Our Ref: 21637-20201106-GDARD Response

ADDENDUM 2 | RESPONSE TO GDARD'S COMMENTS DATED 26 OCTOBER 2020

Steyn City Properties (Pty) Ltd. plans to develop Riverside View Ext 84 on portions 124 and 185 of the farm Diepsloot 388 JR. The proposed zoning of the development will be *Special for: Place of Instructions, Residential buildings and Offices, including ancillary uses such as restaurants and shops* and aims to provide a school, offices and residential buildings. Private Open space will also be incorporated into the development which form parts of the Steyn City Parkland Residence which has been designed to be a modern, mixed land use and mixed income development.

Figure 1: Proposed Wetland Crossing

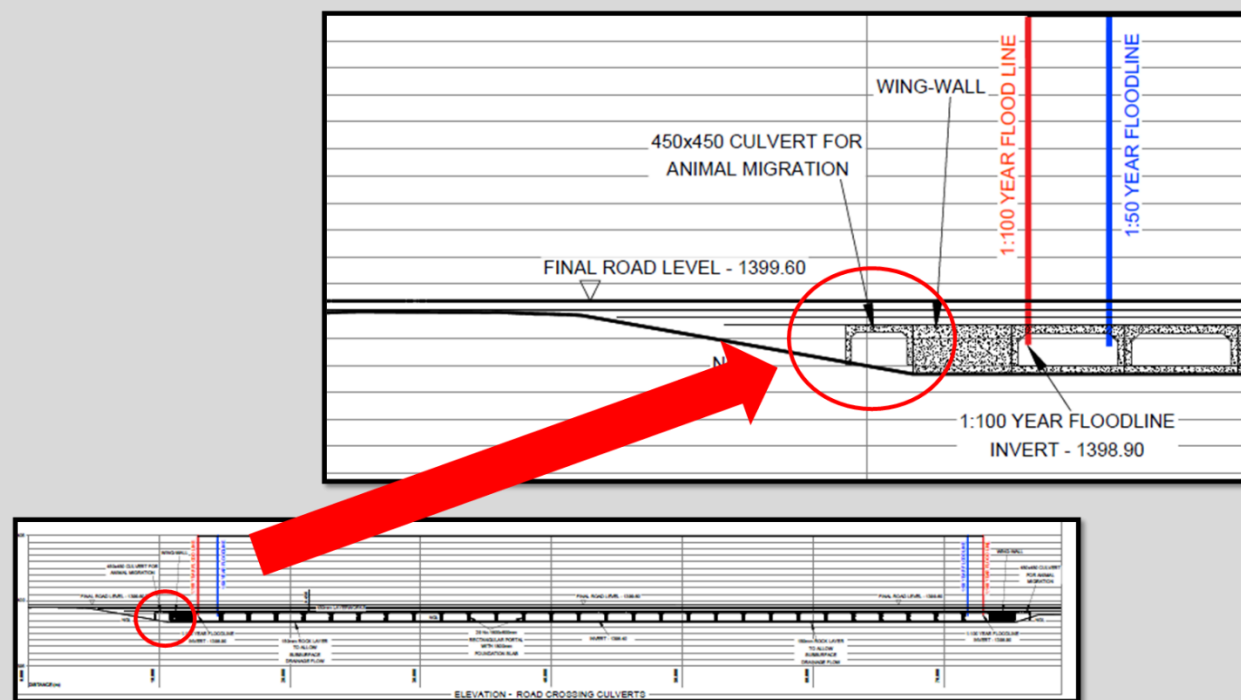
- *The activity 19 of listing notice was applied to cater for the bridge to access Erf 2 the plan bridge must be environmentally friendly so that the animals within the wetland will be able to migrate*

As per Page 12 of the Stormwater Management Plan (Tekciv, 2020) that was included in the Appendix 14.6.9, "A road-bridge will be constructed which allows for the 1:100 year flow of 8.7 m³/s to pass under the road. The bridge is to be constructed of pre-cast portal culverts and will extend the full width of the flood line. To cater for animal crossings, smaller culverts will be placed above the flood line to allow for migration.

Please refer to **Figure 1** below which indicates the proposed wetland crossing including the smaller culverts which cater for animal crossings outside the floodline.

Figure 2: Google Earth Imagery from July 2008

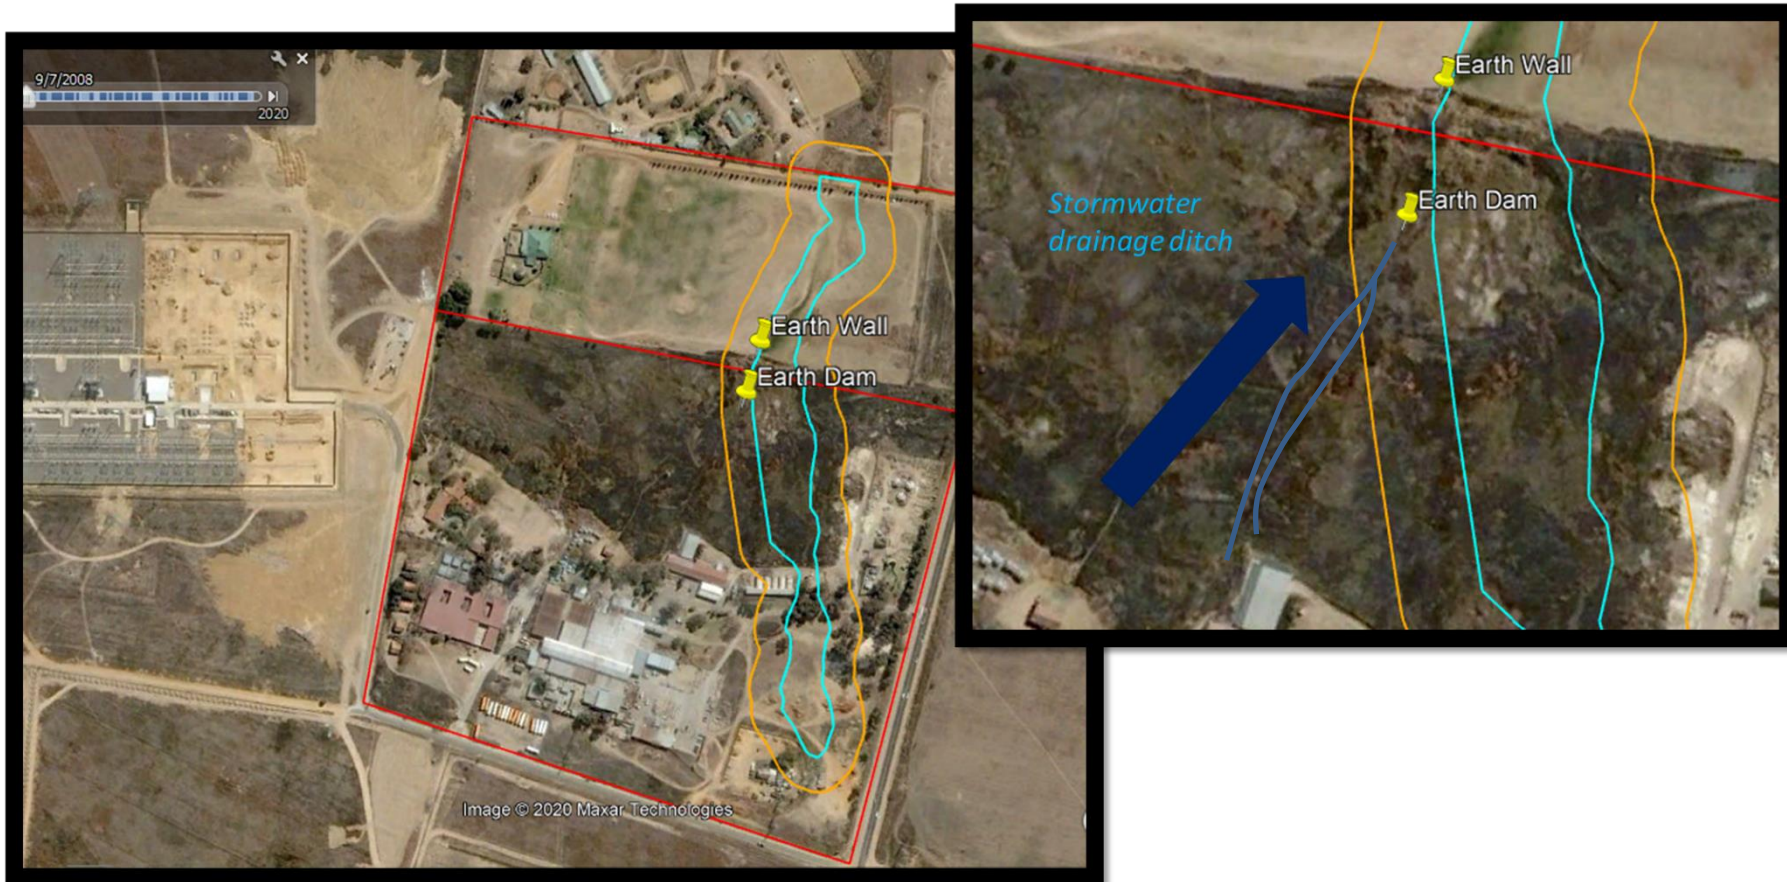
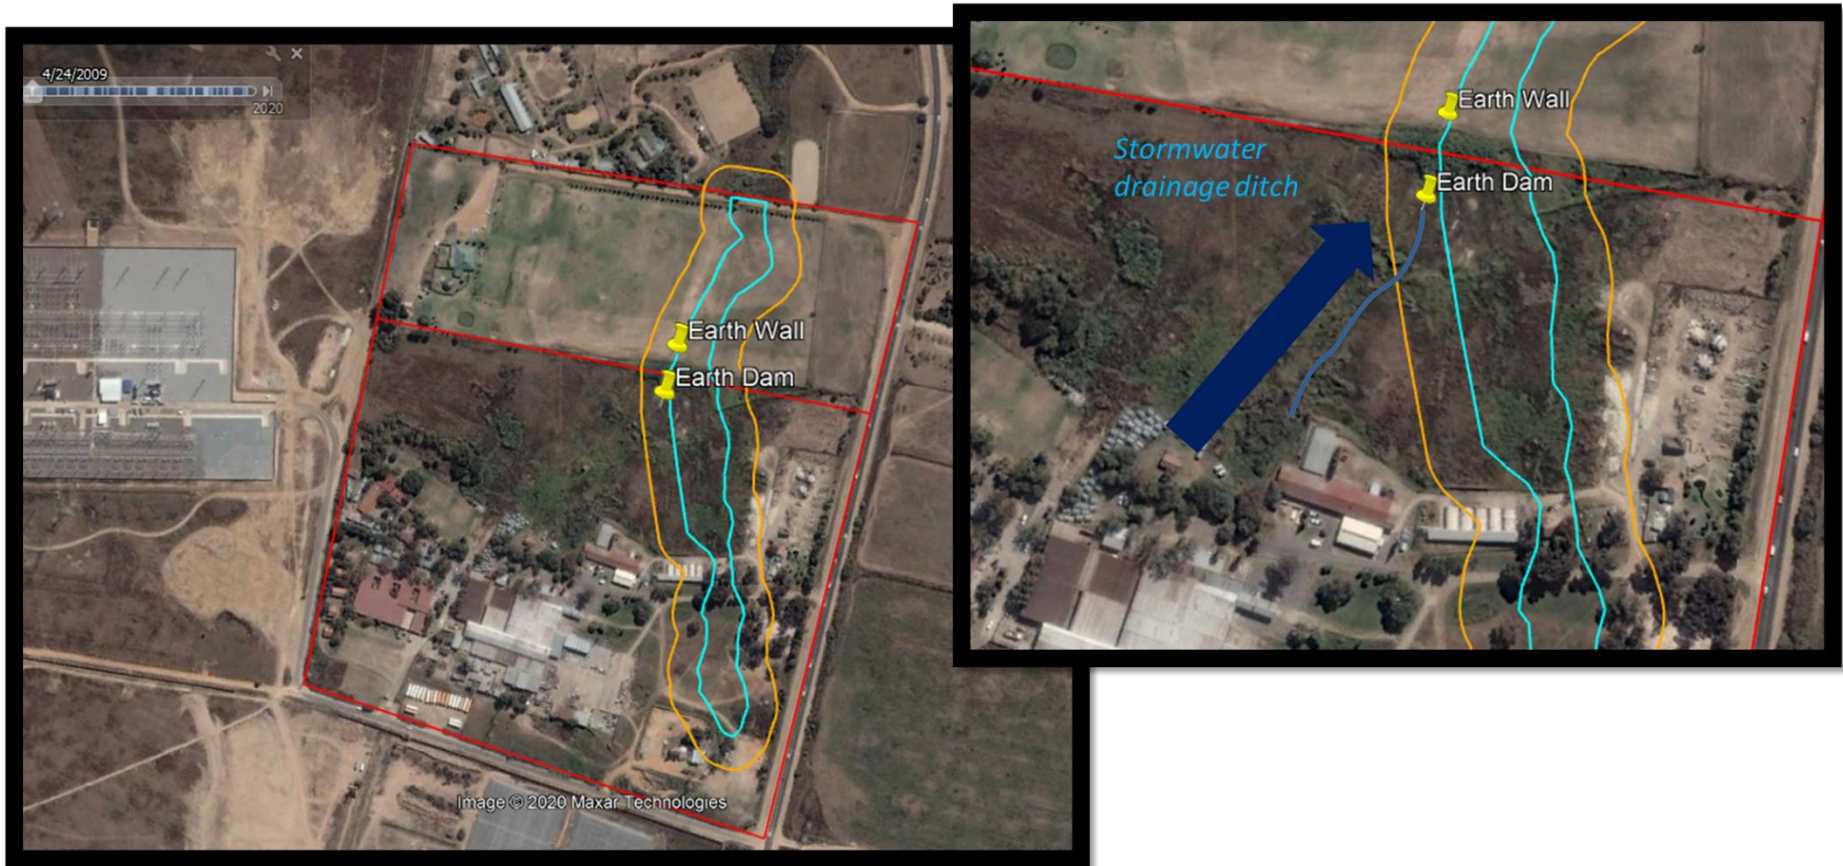
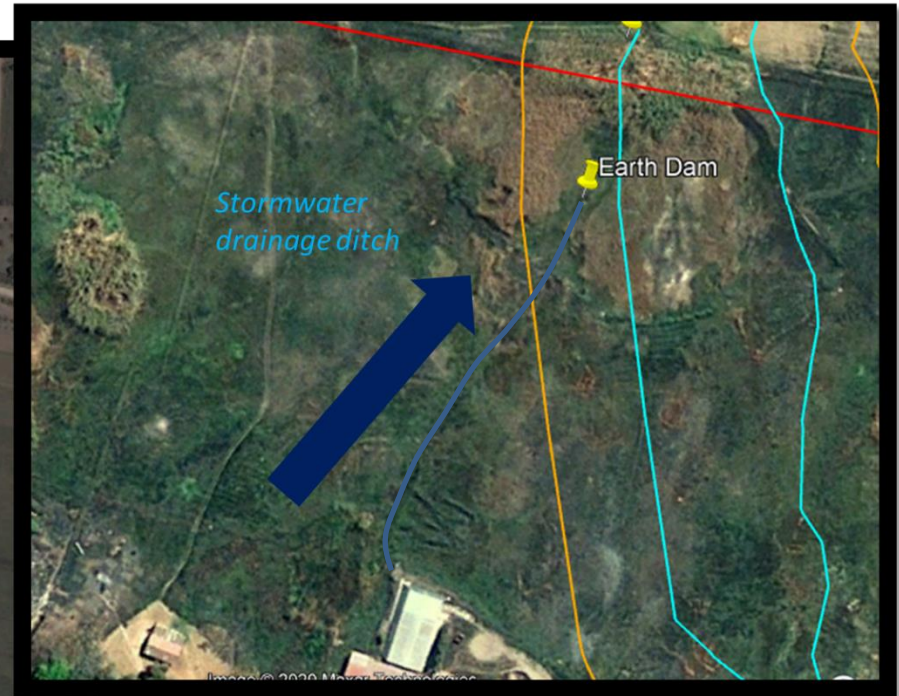
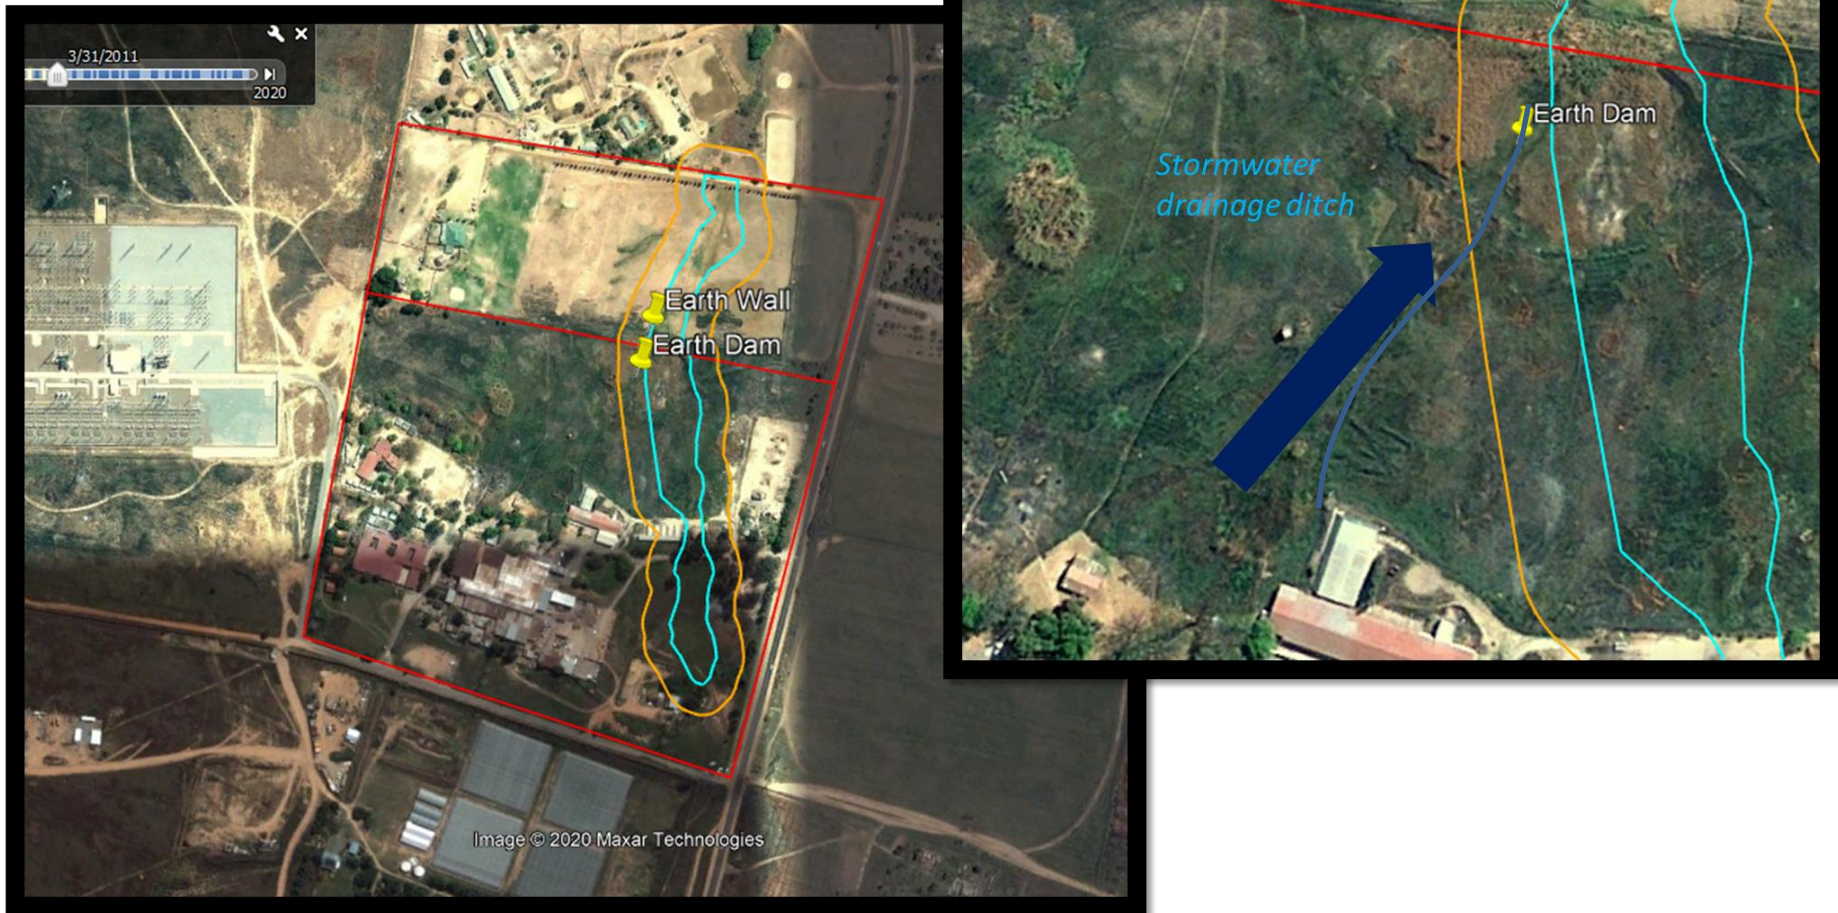
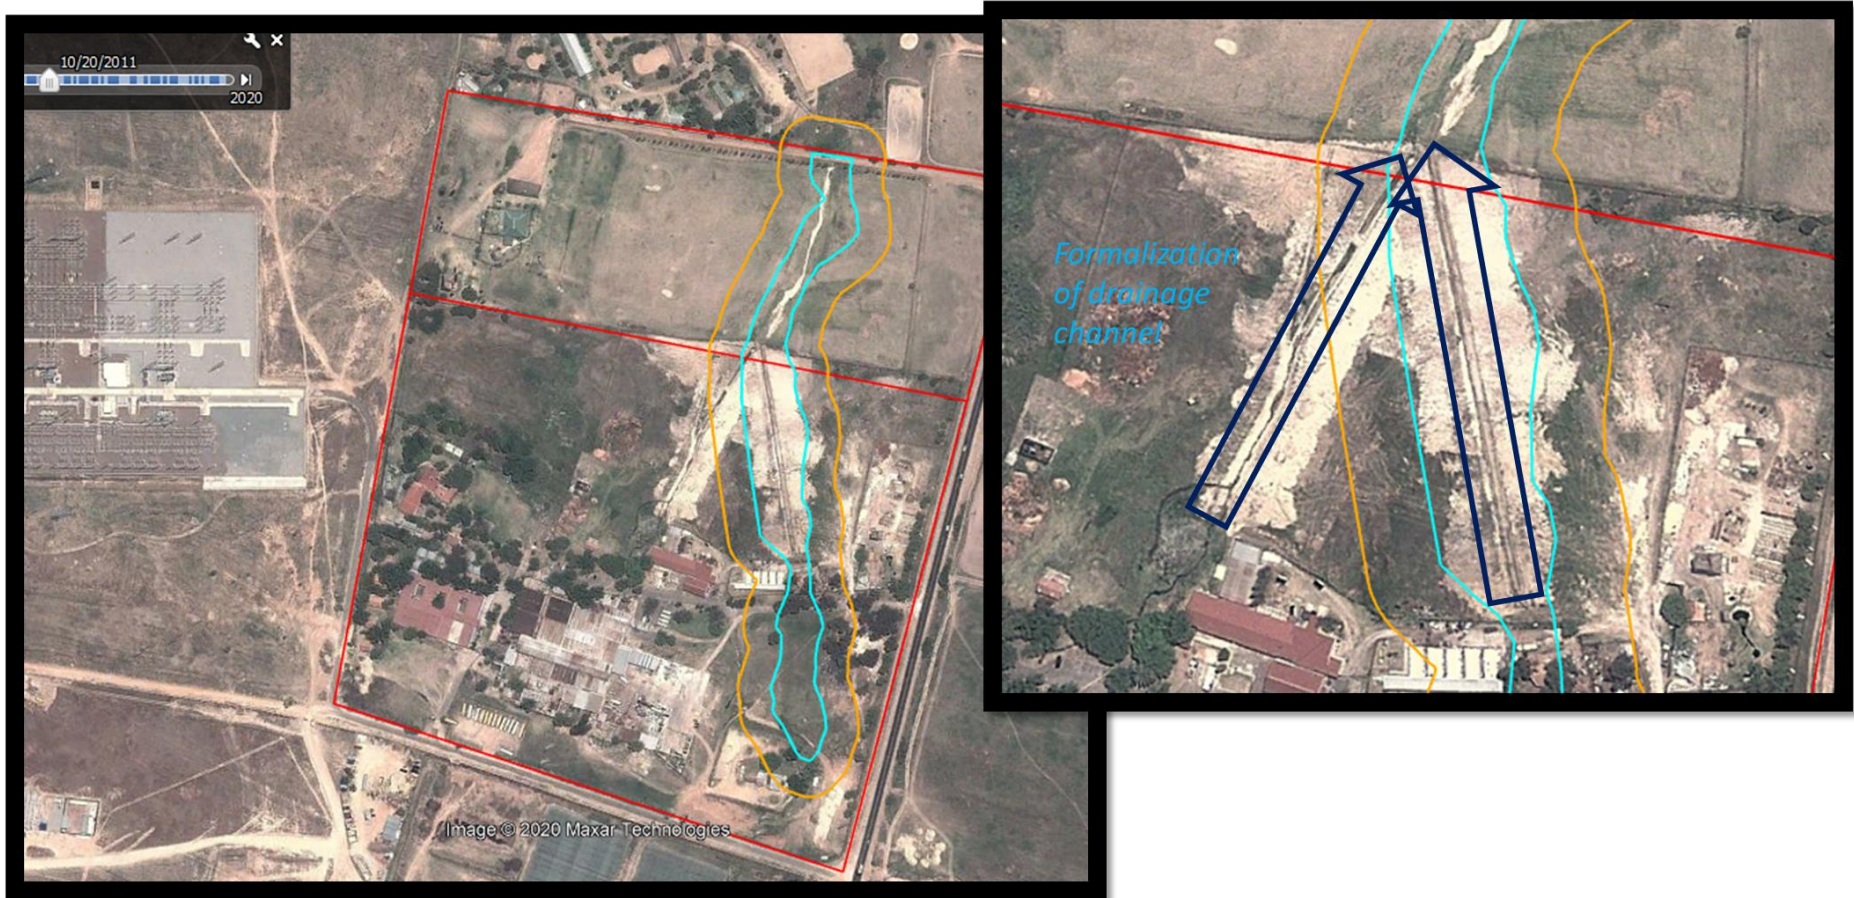
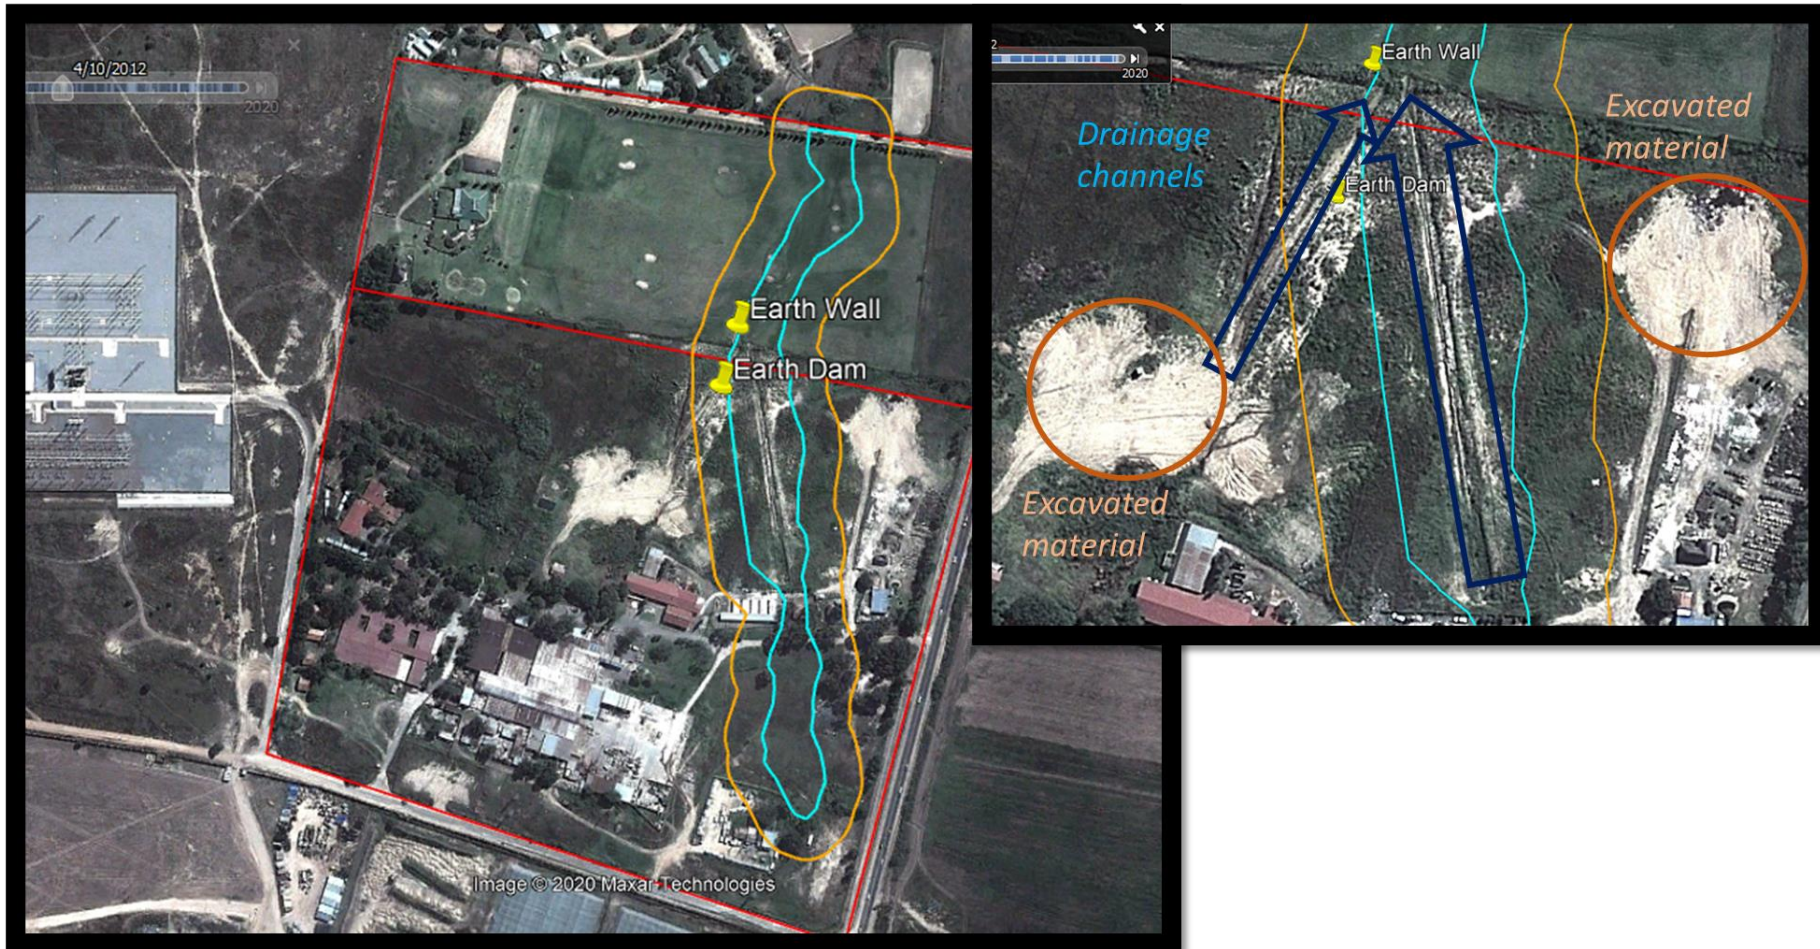
- Page 41 on wetland report indicated as figure 6.4 it display the wetland on site as per the Departmental Information System (GIS) but when its delineated on page 45 as figure 6.8 the other part which is on Erf 1 it's no longer delineated as wetland a clarity must be provided because even on site visit even the reeds were observed on that part.

Discussions with the Wetland Specialist have been undertaken and confirm that the wetland delineation was informed by a number of factors including desktop delineation, flow accumulation models, reference to existing GIS (such as the Department of Water and Sanitation (DWS) database and the National Wetland Map version 5 (NWM5) (Van Deventer et al, 2019)) as well as a detailed site assessment including auguring and a vegetation assessment. In addition to this, the specialist has been involved with the development for a number of years and therefore has a good understanding and experience with the previous development on site. Information from the Geotechnical Reports were also used to corroborate this understanding.

Google Earth imagery has therefore been utilized to provide a summary of the historic use of the site and how this has affected surface water. The aim of this is to provide a timeline and to explain the current status of the site.

From October 2011 to May 2015, a number of changes to the site took place. These occurred after the Geotechnical Reports and thus are not captured within. The exact details of the changes and why they took place is not available. However, evidence from Google Earth as well as the site visits, indicate that that formal drainage channels were put in place in the wetland.

Furthermore, whilst the school and old buildings on Portion 185 were demolished, the platforms they were built on remain in place and thus still channel stormwater and thus form the artificial source of water. This cannot be classified as a wetland and therefore was excluded from the delineation.
